### PLANNED UNIT DEVELOPMENT

STAFF REPORT Date: June 4, 2015

NAME Lot 59 Pinehurst Villa Subdivision

**CONTEMPLATED USE** Planned Unit Development Approval to allow multiple

# SITE PLAN

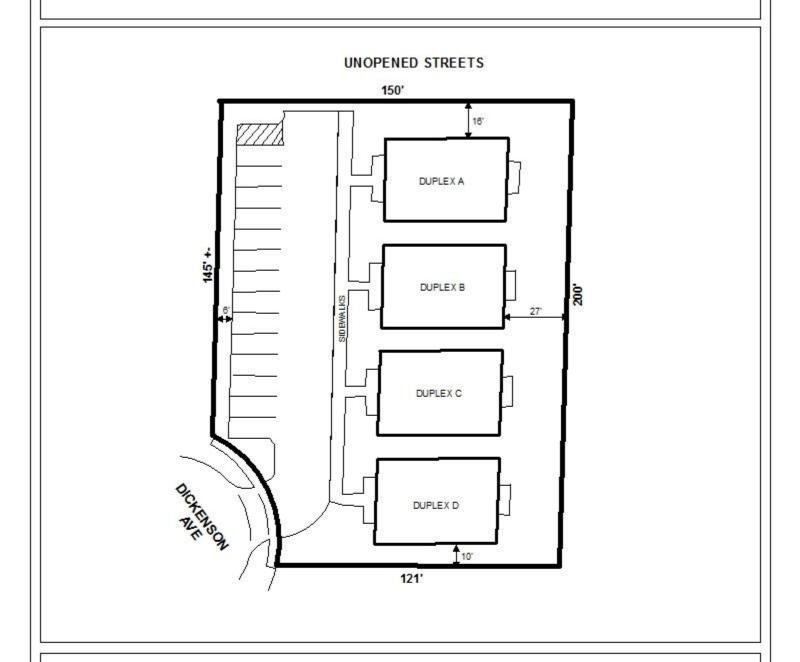
The applicant states that the proposed PUD will abide by the requirements as cited in the Zoning Ordinance for trees and landscaping, as well as the Engineering requirements for on-site storm water detention; however, there are revisions that must be addressed on the site plan in order to bring the property into full site compliance. The site plan should be revised to illustrate compliant landscaping as required by Section 64-4.E of the Zoning Ordinance. This will be inclusive of landscaping percentage requirements, and frontage and perimeter tree planting requirements.

The 25' minimum building set back line is not depicted on the site plan, and should be illustrated on the revised site plan, if approved. Also, the site plan should be revised to provide the lot size in square feet and acres.

The site plan depicts a compliant number of parking spaces required for the site; however, no curbing or bumper stops are indicated for the parking area. The site plan should be revised to indicate curbing or bumper stops within each parking space. In addition to providing the required wheel stops and/or curbing for the parking spaces, the parking area must also provide lighting in compliance with Section 64-6.A.3 of the Zoning Ordinance.

The size and location of the mechanical equipment proposed for each residential unit must be depicted on the site plan and should ensure that it is compliant with Section 64-4.D.11 of the Zoning Ordinance.

The applicant states that garbage collection will be provided by city services; however, The City of Mobile Public Works Department does not service curb-side pick-up for multifamily apartments. The site plan should be revised to illustrate a dumpster compliant with Section 64-4.D.9 of the Zoning Ordinance, or a note should be placed on the site plan stating that no

dumpster will be utilized and garbage collection will be provided by private can collection services.

Furthermore, it appears that a sidewalk is depicted along the entrance to the property on Dickenson Avenue; however, it is unclear. If approved, the side walk will need to be labeled, or if the applicant chooses to forgo this requirement a request for a Sidewalk Waiver must be made. It should be noted that there do not appear to be any sidewalks along Dickerson Avenue.

As a means of access management, a note should be required on the revised site plan, if approved, stating that the PUD is limited to the one curb cut to Dickenson Avenue, with the size, location and design to be approved by Traffic Engineering and conform to AASHTO standards.

- 1) Revision of the site plan to illustrate compliant landscaping as required by Section 64-4.E of the Zoning Ordinance;
- 2) Revision of the site plan to depict the 25' minimum building set back line;

- 3) Revision of the site plan to indicate curbing or bumper stops within the parking area;
- 4) Placement of a note on the site plan stating that lighting in the parking area shall be provided in compliance with Section 64-6.A.3 of the Zoning Ordinance;

- 5) Revision of the site plan to illustrate the size and location of proposed mechanical units;
- 6) Revision of the site plan to illustrate a dumpster compliant with Section 64-4.D.9 of the Zoning Ordinance or placement of a note on the site plan stating that no dumpster will be utilized and garbage collection will be provided by private can collection services;

- 7) Revision of the site plan to label and/or depict a sidewalk or apply for a sidewalk waiver;
- 8) Placement of a note stating that the PUD is limited to the one curb cut to Dickenson Avenue, with the size, location and design to be approved by Traffic Engineering and conform to AASHTO standards;
